ADDENDUM No. 1

RFP No. 23-09

BROOKS STREET IMPROVEMENTS PROJECT

CITY OF ANN ARBOR - PUBLIC SERVICES - ENGINEERING
BROOKS STREET IMPROVEMENTS
BROOKS STREET WATER MAIN

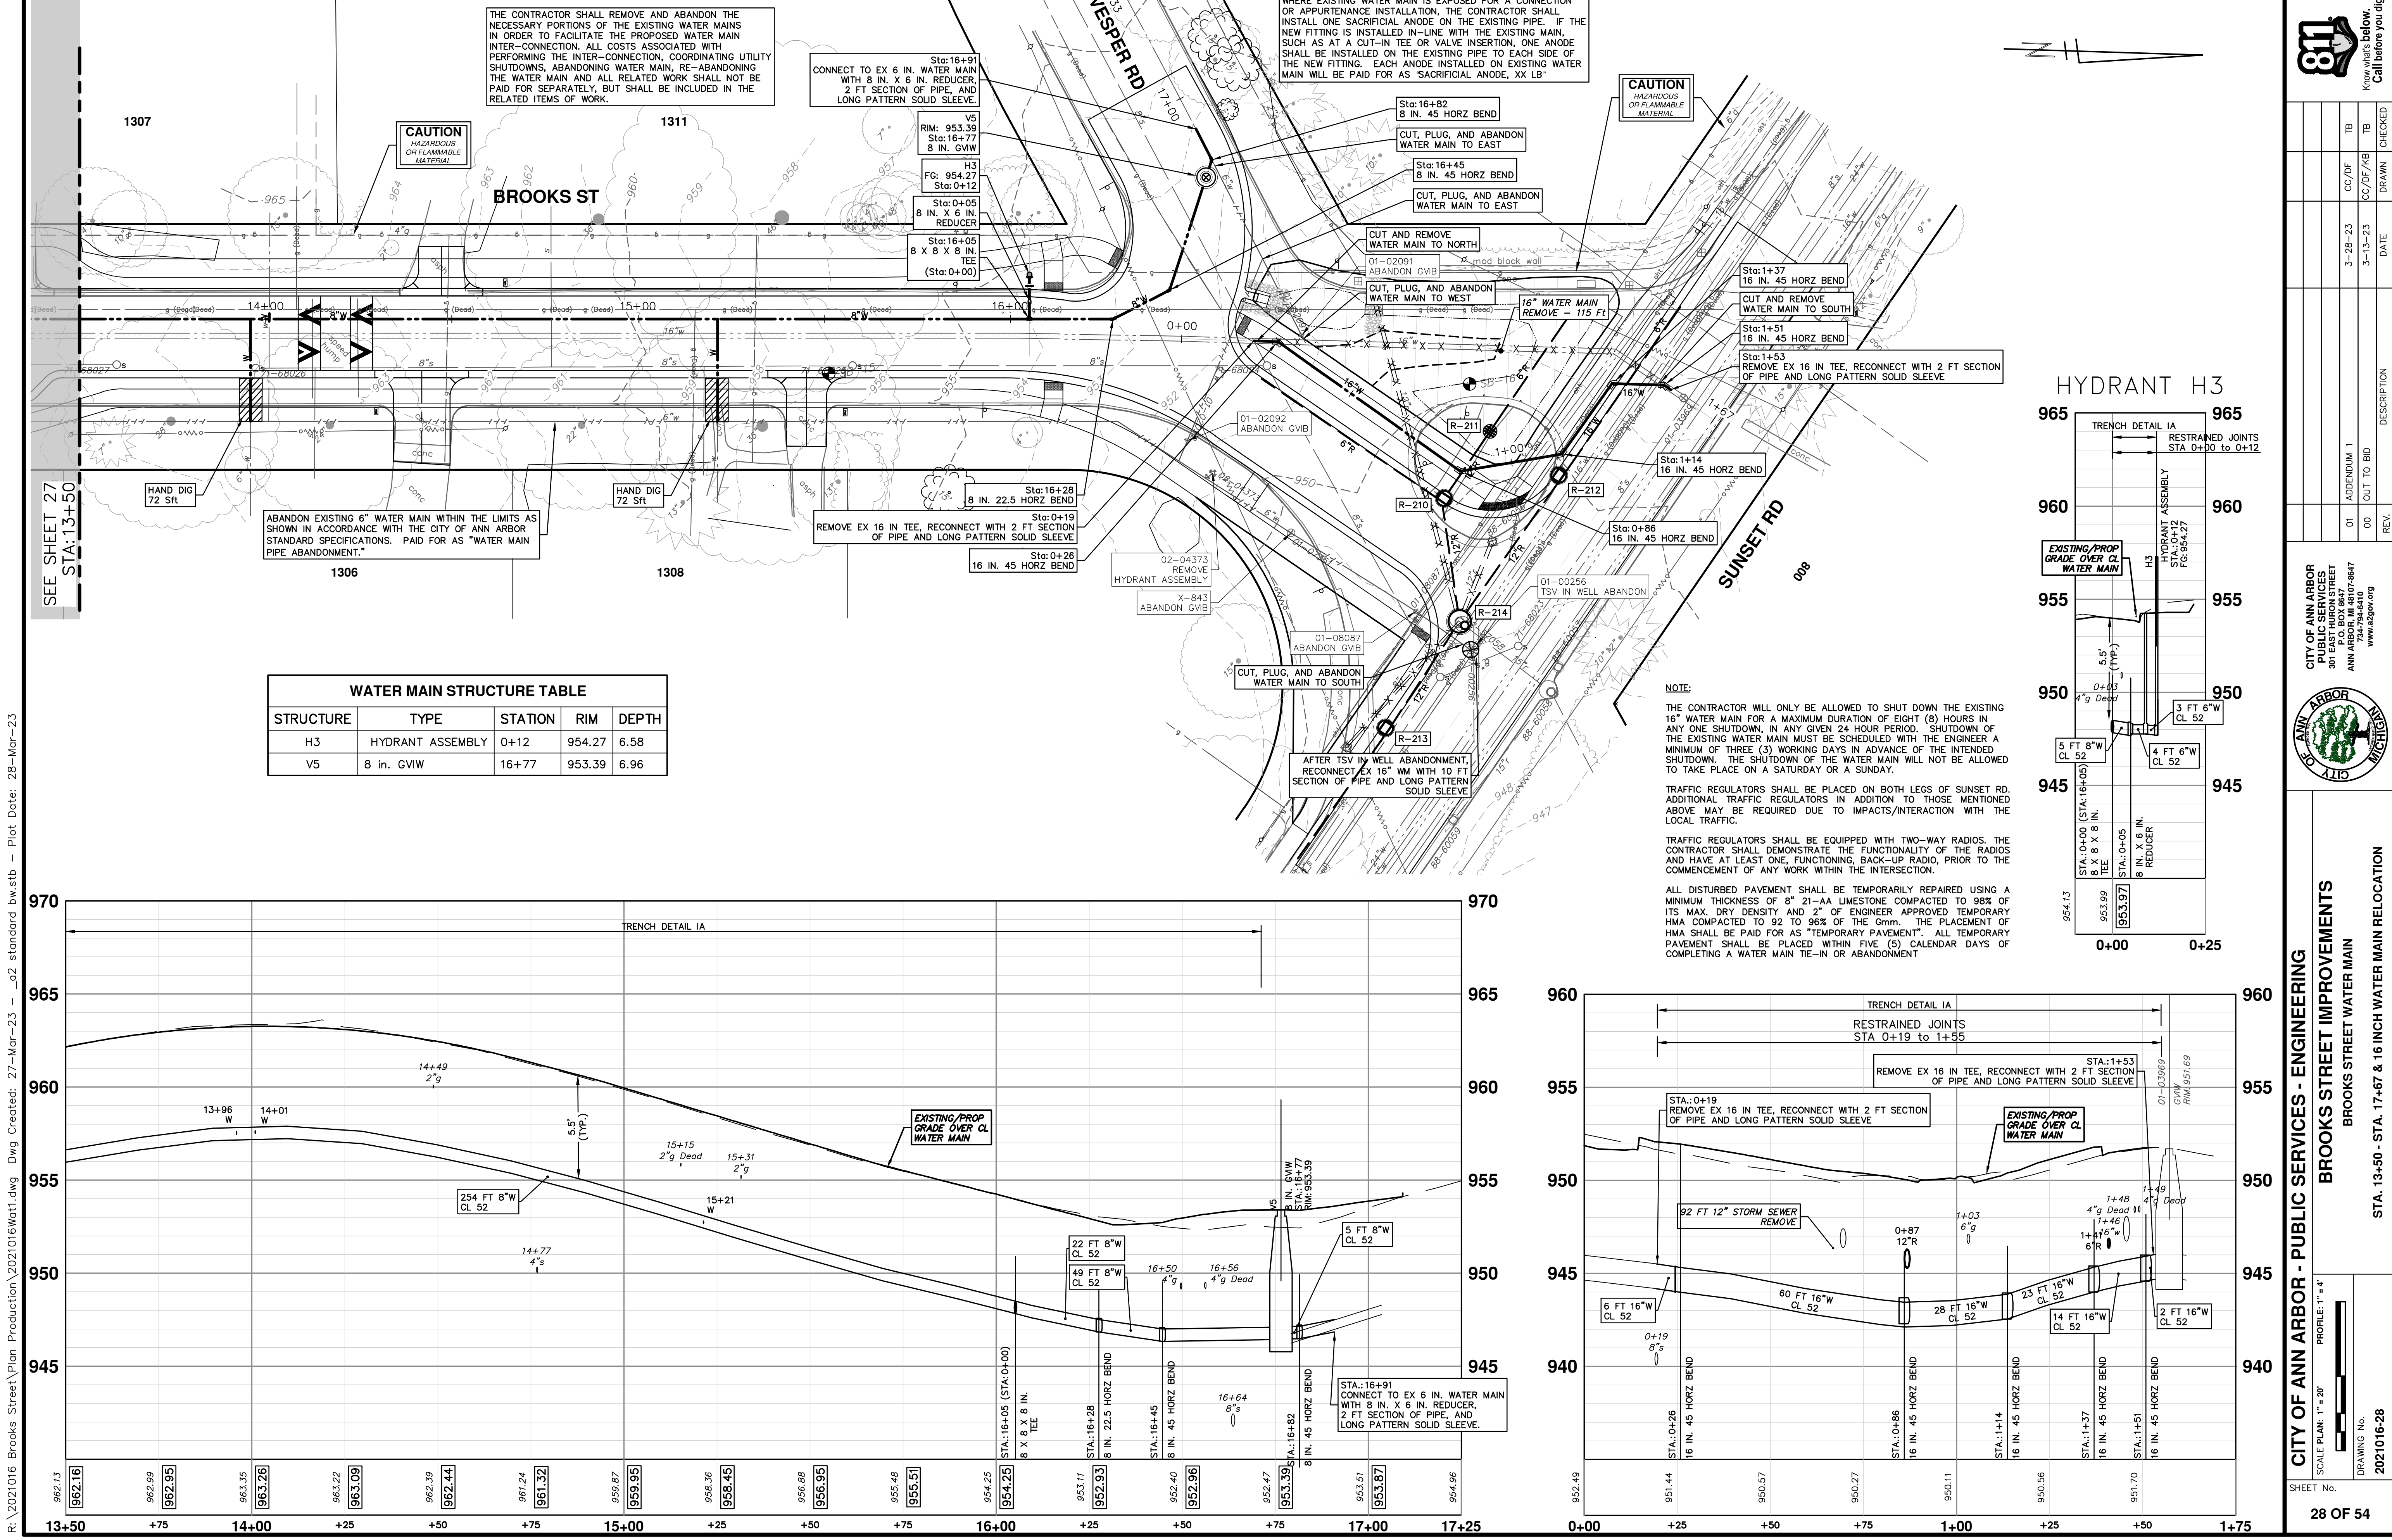
VI/ Page DS-134	Infiltration Trench DS: Replaced with Bioretention and Adjacent Plantings Detailed Specification.
VI/ New section	Trees and Plantings DS: Added.
Plan Sheet 5	Typical Edge Drain Trench specifies MDOT Class 2NS Sand Backfill
Plan Sheet 7	Additional Curb details to reflect scope increase at the intersection of Mixtwood and Red Oak
Plan Sheet 8	Cross sections updated with additional subgrade preparation; HMA Application Table Top and Leveling revised
Plan Sheets 9-11	Cross sections updated to remove sand subbase
Plan Sheet 19	Quantities and units updated
Plan Sheets 21-23, 38, 40, 51	Added 4 bus stop pads and revised location of Mixtwood and Brooks crosswalk
Plan Sheets 23, 42, 46, 49	Reduced scope on Bydding. Match lines eliminated.
Plan Sheets 24, 45	Increased scope at the intersection of Mixtwood and Red Oak
Plan Sheet 28	Added 16-inch watermain relocation around the bioretention area, and removal of 16-inch watermain under the bioretention area

SHEET No. **40 OF 54**
SCALE PLAN: 1" = 20'
PROFILE: 1" = 4'
DRAWING No. **2021016-40**
STA. 19+00 - STA. 23+50

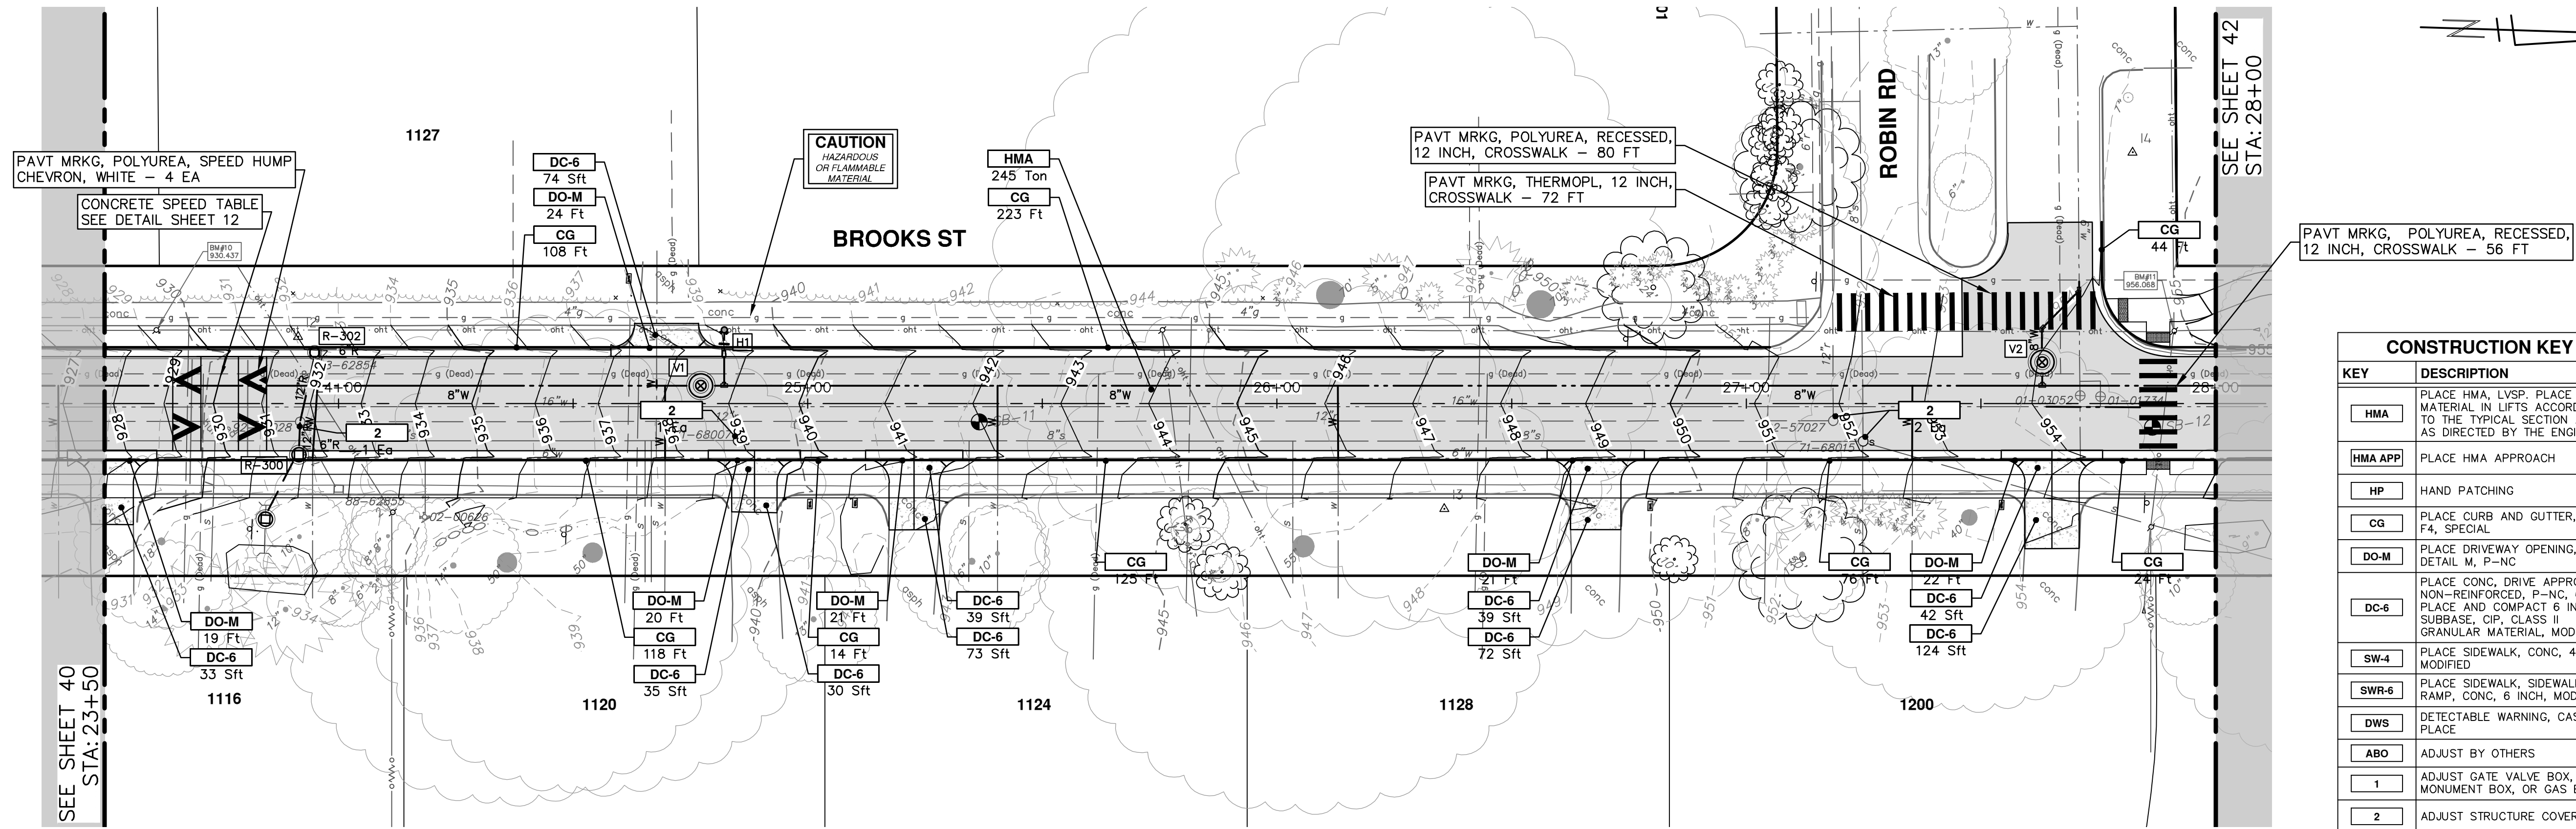
Plan Sheet 33	Revised R-212 structure type, inverts and depth at R-214, and eliminated sump on R-214; revised perforated pipe under bioretention
Plan Sheet 34	Bioretention quantities (Cut and Geotextile fabric) added
Plan Sheets 39, 41	Addition of Thermoplastic Crosswalk Pavement markings
